**ADDENDUM NUMBER: #2**

Project Name: Falfurrias Jr High School  
Parking Lot

Milnet Project No.: 218010

FALFURRIAS JR H.S. PARENT DROP OFF /  
PARKING LOT  
BROOKS COUNTY ISD  
FALFURRIAS, TX

### ASPHALT PAVEMENT (LIGHT DUTY) SECTION

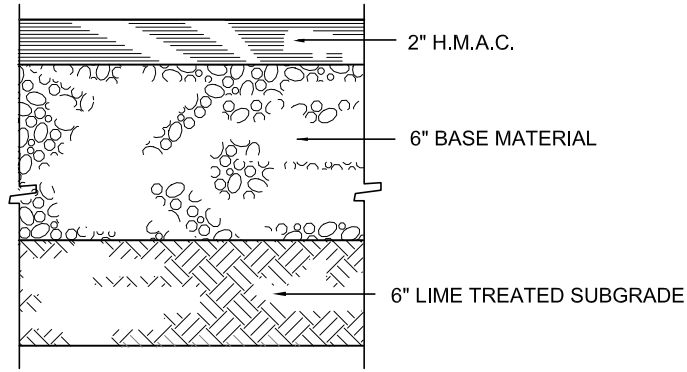
1.01 **Bidder Question:** Proposal form indicates alternate for asphalt paving, can a section for asphalt paving be provided?

**Answer: Re:** Attached asphalt pavement sections.

NOTE: SECTION AS PER TERRACON GEOTECH RECOMMENDATIONS, SEE REPORT FOR MORE INFORMATION.

NOTE: ALL MATERIALS SHOULD MEET THE CURRENT DEPARTMENT OF TRANSPORTATION (TXDOT) STANDARD SPECIFICATIONS FOR HIGHWAY AND BRIDGE CONSTRUCTION.
